**MONTGOMERY COUNTY HISTORIC PRESERVATION COMMISSION**  
**STAFF REPORT**

<b>Address:</b>	46 Philadelphia Ave., Takoma Park	<b>Meeting Date:</b>	12/20/2023
<b>Resource:</b>	Contributing Resource <b>Takoma Park Historic District</b>	<b>Report Date:</b>	12/13/2023
<b>Applicant:</b>	David Bates & Anne LeVeque Brian McCarthy, Architect	<b>Public Notice:</b>	12/6/2023
<b>Review:</b>	HAWP	<b>Tax Credit:</b>	Partial
<b>Case Number:</b>	1051682	<b>Staff:</b>	Dan Bruechert
<b>Proposal:</b>	Partial Demolition, Rear Addition, Fenestration Alteration, and Roof Replacement

**A200**

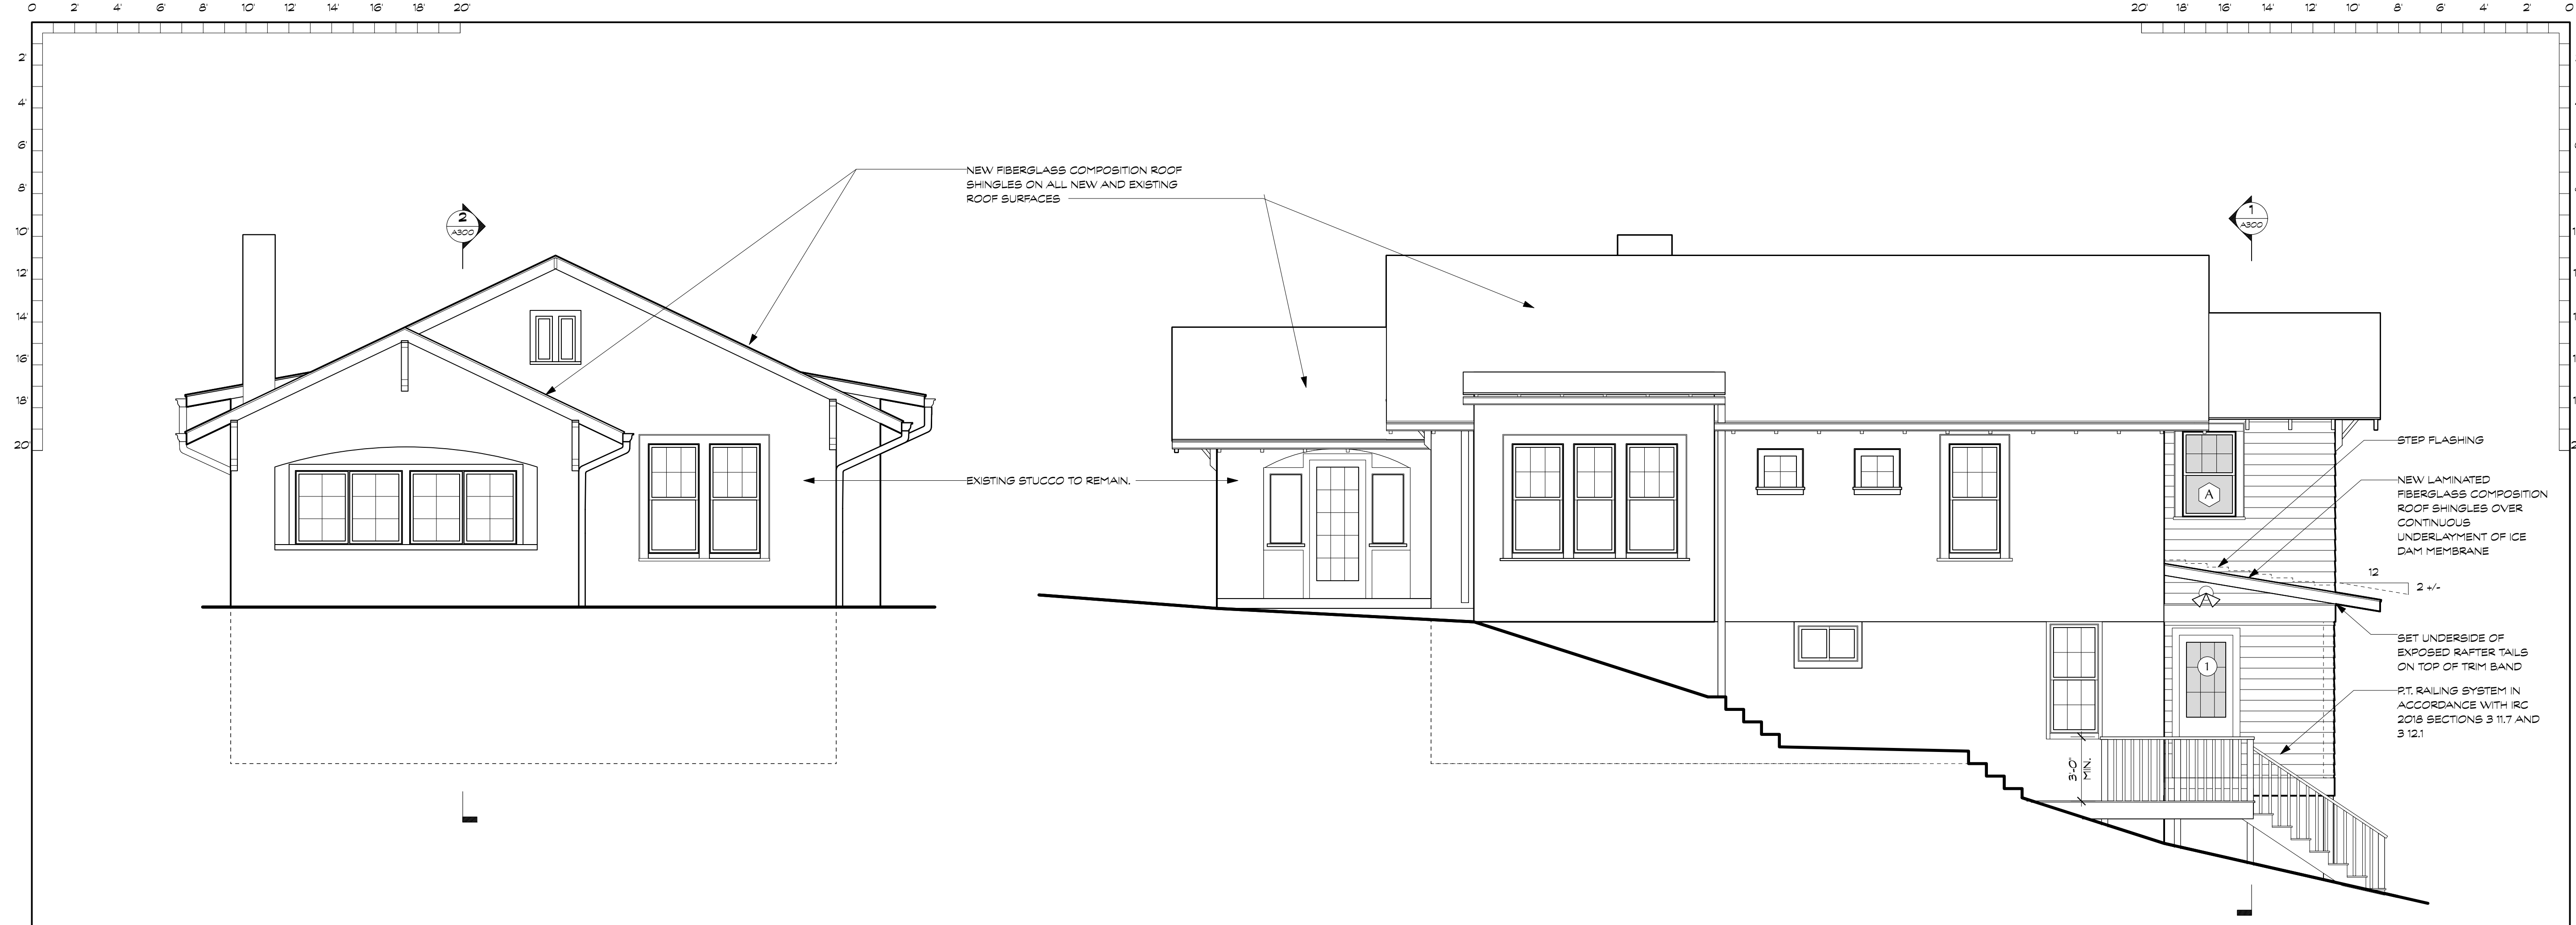
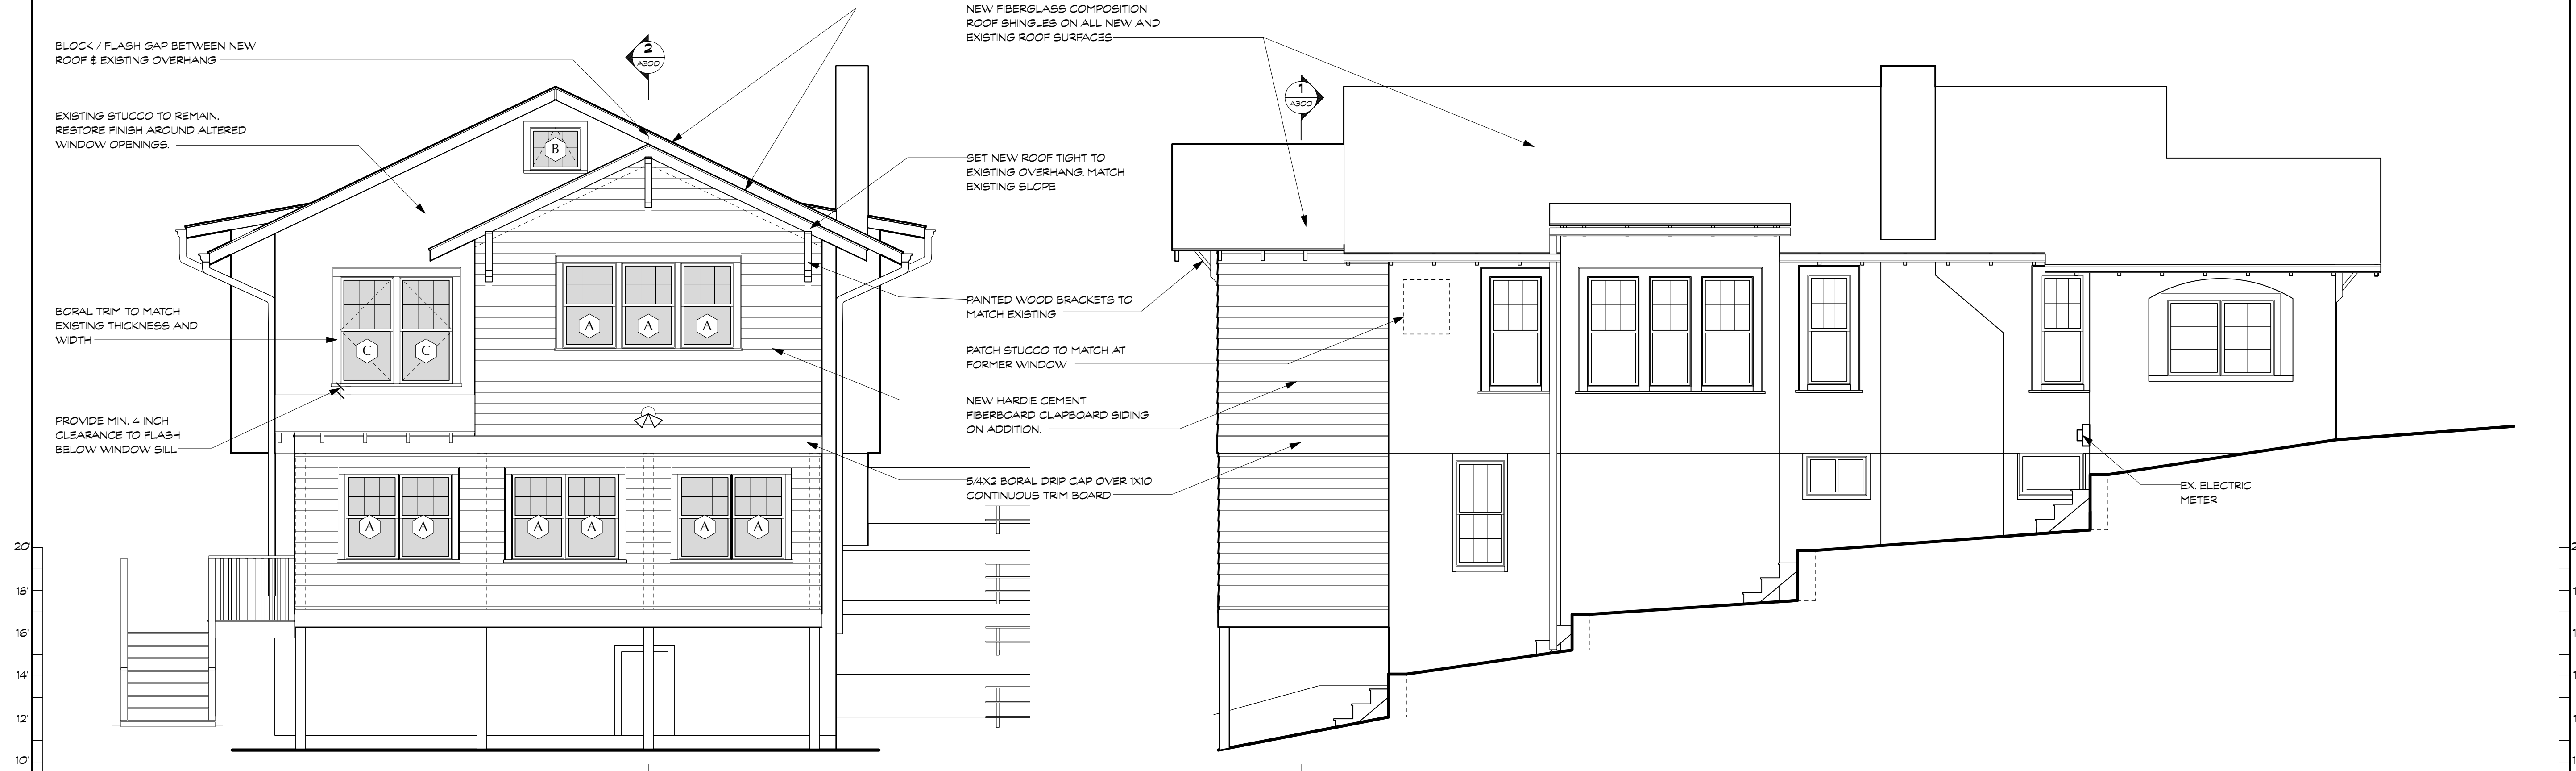
On the left elevation of the historic house, near the rear corner, the applicant proposes to remove an existing four-light fixed window and patch the opening with stucco to match the existing siding. The window appears to be a historic opening. The window removal is proposed to accommodate the new interior layout.

The *Design Guidelines* state original size and shape of window and door openings should be preserved. Staff finds the placement and limited visibility of this window will not substantially change the character of the resource or the surrounding district and recommends the HPC approve the window removal under 24A-8(d).

6. All elevation and plan drawings shall be updated to note the porch and stair floorboards shall be wood or Aeratis. If Aeratis is chosen, specification sheets shall be submitted as part of the revised set of drawings.

7. All elevation and plan drawings shall be updated to note the handrail system shall be wood. If a substitute material is shown, specification sheets shall be submitted as part of the revised set of drawings and approval of the material is delegated to staff.
